#### HISTORIC AND DESIGN REVIEW COMMISSION

November 02, 2016 Agenda Item No: 11

**HDRC CASE NO:** 2016-377 **ADDRESS:** 135 E COMMERCE ST **LEGAL DESCRIPTION:** NCB 106 BLK LOT 35 (WITTE BUILDING I SUBD) **ZONING:** D HS RIO-3 **CITY COUNCIL DIST.:** 1 LANDMARK: Witte Building Andrew Douglas/Douglas Architects **APPLICANT:** Chris Hill/135 E Commerce LLC **OWNER:** Amendments to previously approved design/ construction of a stair and elevator **TYPE OF WORK:** tower

135 E. Commerce - Witte Building: Historic Design Review Commission Presentation

### WITTE BUILDING | EXISTING HUGMAN RIVERWALK STAIR

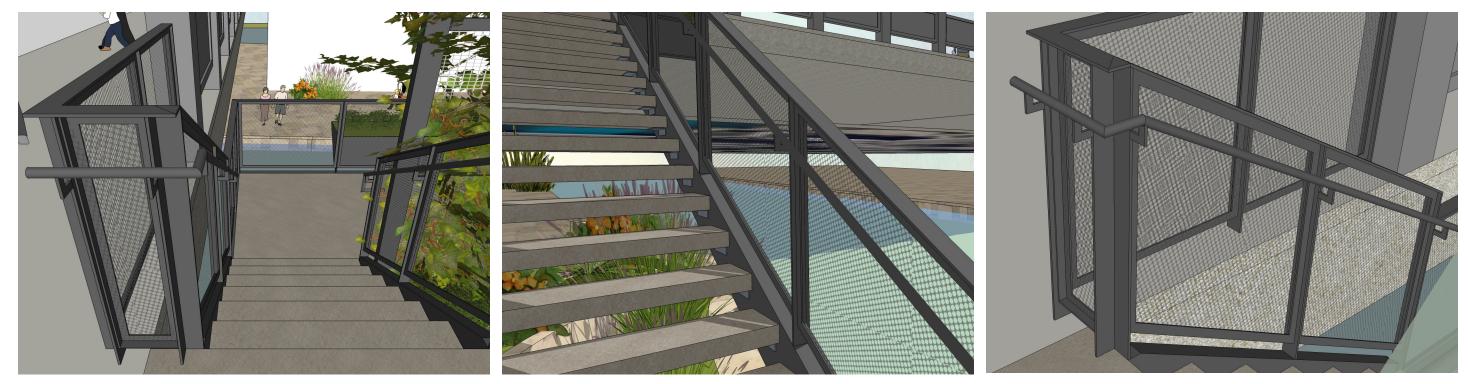
Existing Hugman River Walk Stair\* + Proposed Witte River Walk Stair \*using the most pertinent example as a reference for inspiration and re-interpretation

- Hugman descent that turns at an overlooking landing
- Witte 3'x12' landing overlook outside of the circulation path builds upon this concept [specific space provided to allow for pause and observation]

- Hugman concrete treads and risers
- Witte also concrete, but reinterpreted with open risers and diamond polished treads [flood water can flow through / durable material / special treatment of surface]

• Hugman – one material - wrought iron; simple and open to allow a view to the river

• Witte – one material in different forms - bar, angle, sheet; perforated metal sheets allows a view through [high openness factor] while complying with current code [4" sphere cannot pass]; circles reference the dots of the fritted glass

- Hugman special detailing to celebrate the column
- Witte structure made special by eliminating the need for columns wide flange beams support the landing without imposing on the river walk below [a necessity because the walkway at this part of the river has culverts beneath it and cannot support columns]

- Hugman pots hung from rail to soften the manmade construct [additive element]
- Witte reinterpreted as the folded wall of vegetation that shades the elevator tower [element that circulate under and around]; also, a planter at the landing softens this place of pause [could add fragrance and color to the experience]

### WITTE BUILDING | PROPOSED RIVERWALK STAIR

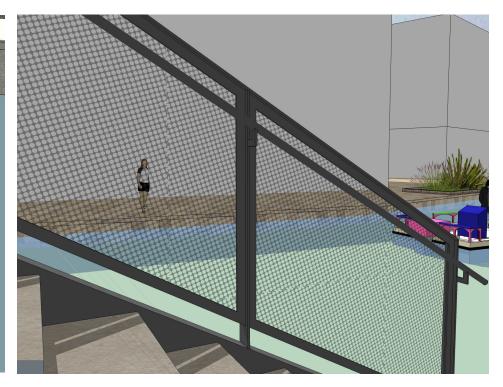
- g. STAIR MODIFICATION The applicant has proposed modifications to the proposed detailing of the stair, primarily at the River Walk level to street connection. The applicant has proposed a stair that features materials that include polished concrete and perforated metal. While these materials may be similar to those found in original Hugman elements, their application is drastically different in design, scale and context.
